## Product Change Notice (PCN)

**PCN Number:** PCN-0451152R-01

**Product(s) Affected:** PJ-038A, PJ-038B, PJ-038AH, PJ-038BH

Current version	New version
Outlook		
Front	<p>without chamfer</p> 	<p>with chamfer</p>

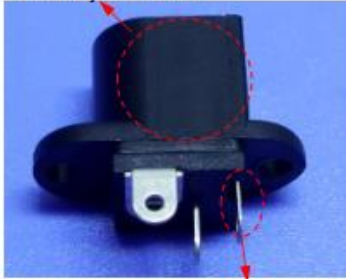
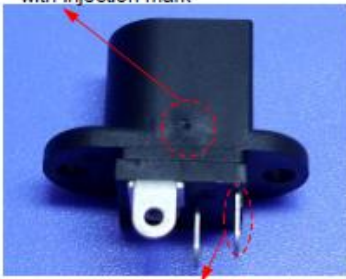
**Description of Change:** Thickness of pin 2 changed from 0.2mm to 0.25mm. Aesthetic changes as shown in below comparisons:

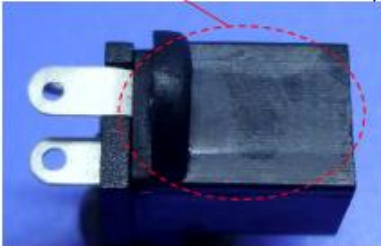
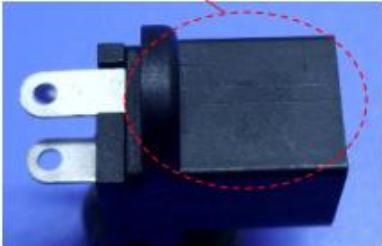
<p>Back</p>	<p>cave marking location</p>  <p>cave marking location</p>	<p>cave marking location cave marking location</p> 
<p>Top</p>	<p>without injection mark</p>  <p>thickness of pin#2 is 0.2mm</p>	<p>with injection mark</p>  <p>thickness of pin#2 is 0.25mm</p>
<p>Bottom</p>	<p>rough surface with injection mark</p> 	<p>smooth surface with injection mark</p>
